## Modifications Notices

No. 2017086AE(ON)

### Modification Notice of MIL flat cable connector model XG4H series marking method and shape design for product quality improvement.

Model XG4H series

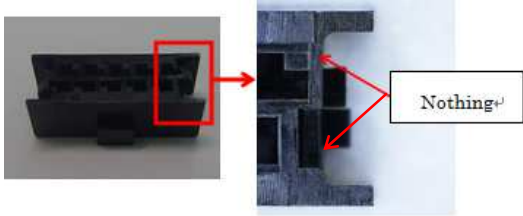
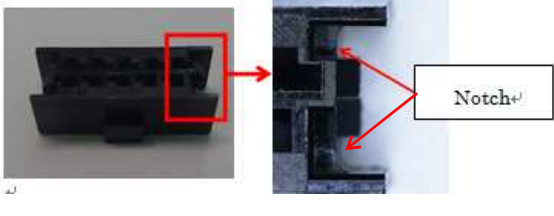
Before the change	After the change
<p><b>Change shape of the housing (Model XG4H-□□□1 only)</b> The both ends of the housing do not have a notch.</p> 	<p><b>Change shape of the housing (Model XG4H-□□□1 only)</b> The both ends of the housing have a notch.</p> 
<p><b>Change marking method</b></p>  <p>Heat transfer printing</p>	<p><b>Change marking method</b></p>  <p>Heart stamp</p>

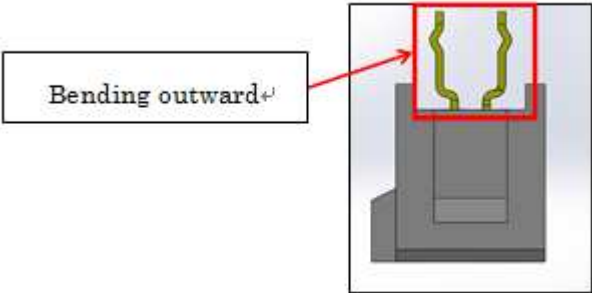
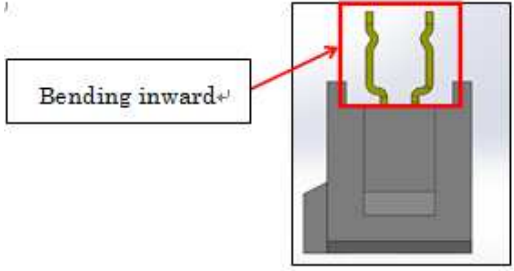
Before the change	After the change
<p><b>Change shape of kink contact (Model XG4H-□□31-1 only)</b></p>  <p>Bending outward<sup>①</sup></p>	<p><b>Change shape of kink contact (Model XG4H-□□31-1 only).</b></p>  <p>Bending inward<sup>①</sup></p>
